How to change Mini Card to mSATA on GENE-QM67

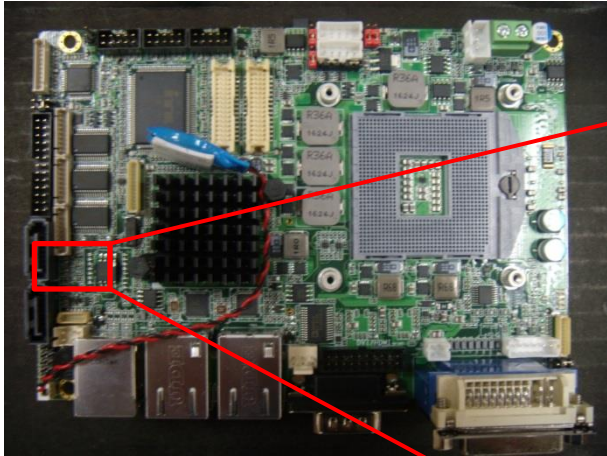
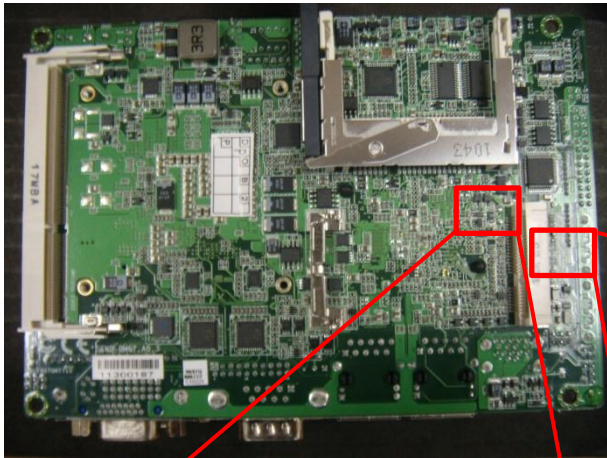
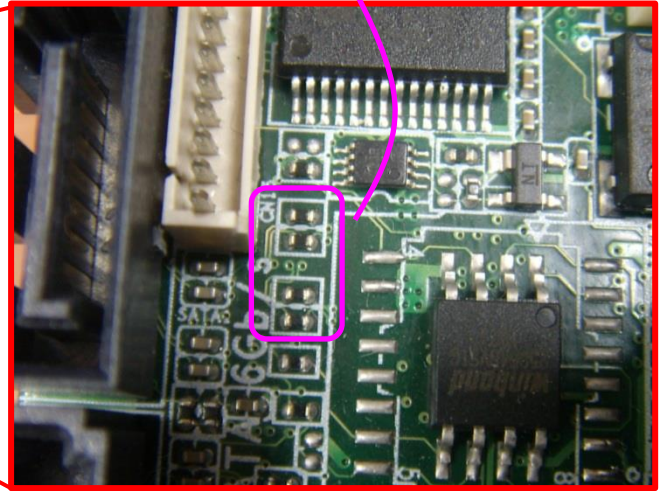
1. Remove 4 resistors as below

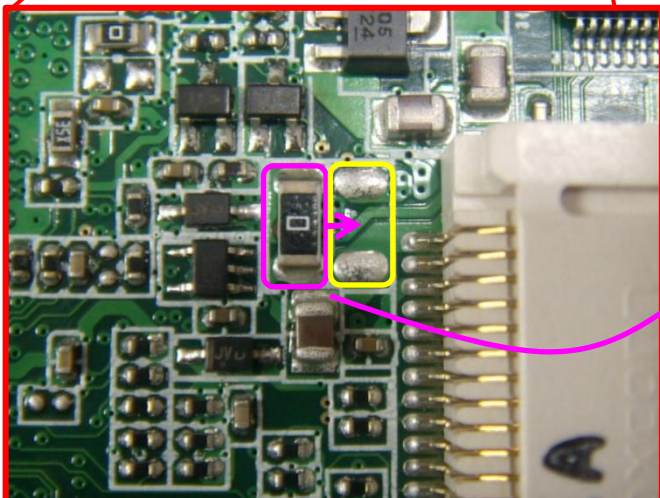
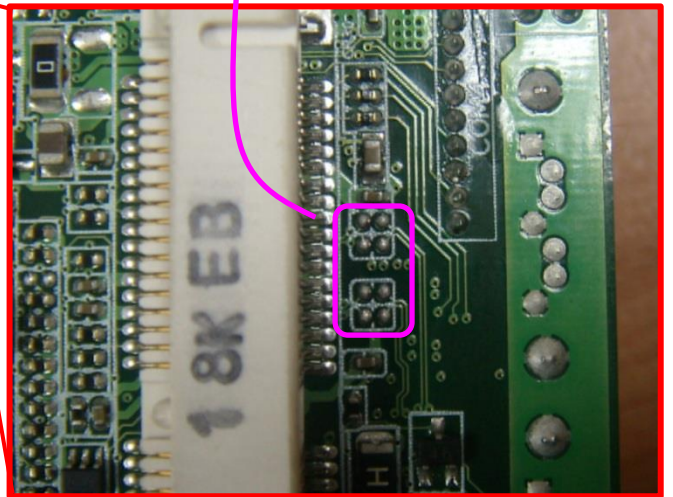
2. Add 4 capacitors to below location
CAP value: 0.01uF, Size 0402

3. Move the 1210 resistor right by original location.
